CDM: Recommendation Form for Small Scale Methodologies (version 01)
(To be used for presenting questions/proposals/amendments to the simplified methodologies for small-scale CDM project activity categories)

Date of SSC WG meeting:	11–14 January 2011, SSC WG 29
Title/Subject (give a small title or specify the subject of your submission, maximum 200 characters):	Revision of AMS-III.Q to include multiple fuels in the baseline electricity source and multiple waste heat sources
Indicative methodology to which your submission relates (refer the items of Appendix B of the Simplified Modalities and Procedures), if applicable.	AMS-III.Q “Waste Energy Recovery (gas/heat/pressure) Projects”
Name of the authors of the query:	Luca Morganti Institution: First Climate Group Mischa.Classen@firstclimate.com , Luca.morganti@firstclimate.com

SSC-Submission number	SSC_497
Date when the form was received at UNFCCC secretariat	14 January 2011
Date of transmission to the EB	14 January 2011
Date of posting in the UNFCCC CDM web site	14 January 2011

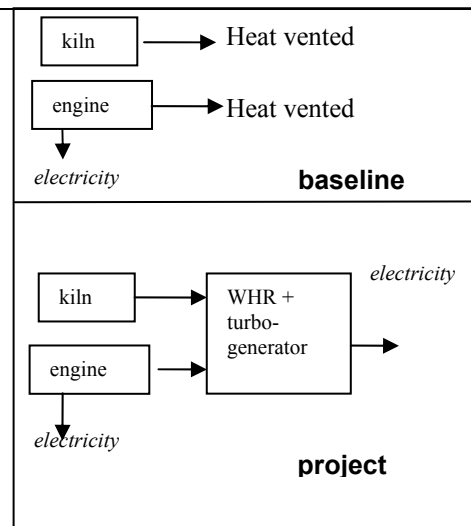
1. “Please clarify whether the case is just an example and represents hypothetical situation or represents an actual project.”

2. We understood that waste heat from Kiln and IC engine will be recovered to produce steam using waste heat recovery boiler. The steam will be used to produce additional electricity (addition to the amount that is produced by the IC engine) through an installation of a new steam turbo-generator. It is however stated in the submission that “Although steam is generated in separate waste heat recovery boilers, it is fed to the same steam turbine to produce electricity”. Please clarify.

3. It is not clear in the submission how the additional electricity would have been produced in the absence of the project activity. In other words, what is the baseline for the additional electricity produced? Is the facility connected to a grid and in the baseline electricity is imported while the additional electricity produced during the project displaces the grid and/or export to the grid?

4. Please note that conversion from single cycle to combined cycle project activity is excluded from AMS-III.Q “Hydrogen production using methane extracted from biogas” and a new methodology (AMS-III.AL “Conversion from single cycle to combined cycle power generation”) has been developed in response to the submission SSC-NM048 “Conversion from single cycle to combined cycle power generation “/SSC_359 “Clarification on AMS-III.Q for project activity using incremental gain of waste heat recovery”. The rationale of having a separate methodology for this case is related to the fact that the operation of the single cycle (the turbine or the engine) could be affected (dispatch may be increased) once the conversion is implemented as the combined cycle is relatively more efficient. AMS-III.AL provides procedures to capture this situation. Please clarify how the proposed request for revision addresses this issue. Please note however that AMS-III.AL is not applicable to this particular case where waste heat from an engine is used together with waste from a kiln to produce additional electricity.

The issue of multiple fuels used in captive generation is relevant for several real cases, in particular in Pakistani projects, e.g. DGKCC Waste Heat Recovery and Utilization for 10.4 MW Power Generation at Dera Ghazi Khan Plant, already published for GSC on 24 Mar 10 (<http://cdm.unfccc.int/Projects/Validation/DB/XDNBLIDFFBLQR11A0SD86KIXIF5KUM/view.html>)

The heat from the kiln is fed to a waste heat recovery boiler and steam is produced. The heat from the IC is fed to another waste heat recovery boiler and steam is also produced. The steam from the 2 sources is fed to the SAME steam turbine, built as part of the project activity. The metering of the electricity generated by the WHR equipment is done at the turbo generator, excluding the electricity produced by the IC directly.

Baseline for all the electricity produced (from both heat sources, the kiln and the IC) is grid electricity. In absence of the project activity (which includes the installation of WHR boilers for BOTH sources and the common turbo-generator) the electricity would be supplied by the grid.

We are aware that AMS.III.Q does not cover the conversion from single cycle to combined cycle. The problem is that it is ambiguous in our case whether “adding a WHR unit downstream an IC” in fact qualifies as “conversion from single cycle to combined cycle”. In case it qualifies as such, our request is to amend the methodology in order to exclude cases related to single units in captive power plants serving industrial facilities, which are quite different from full scale grid-connected power plants. In addition, when AMS.III.AL is considered, it is clear that in this case the electricity produced in the baseline by the single cycle system is to be deducted from the total project power generation, and provisions are needed to ensure that the first part of the combined cycle is not modified once the second cycle is added. But this is automatically ensured in the proposed project case, as (i) the electricity produced by the IC is NOT included in the project power generation (only the electricity produced by the new turbo-generator is accounted for the ER calculation) and (ii) it is not possible to influence the IC through operation of the turbo-generator (so the IC will continue operating as in the baseline scenario). On the other hand, if the “addition of a WHR unit downstream an IC for power generation” is not to be interpreted as a conversion from single cycle to combined cycle, then AMS.III.Q is applicable to our case and only a clarification to this regard is needed from you, to make clear to the validating DOE that our case does comply with the applicability conditions of AMS.III.Q. In that case only the first part of our request would be geared towards revising AMS.III. Q to include multiple fuels in the baseline. The second request on multiple heat sources could be dealt with by a simple clarification from your side.
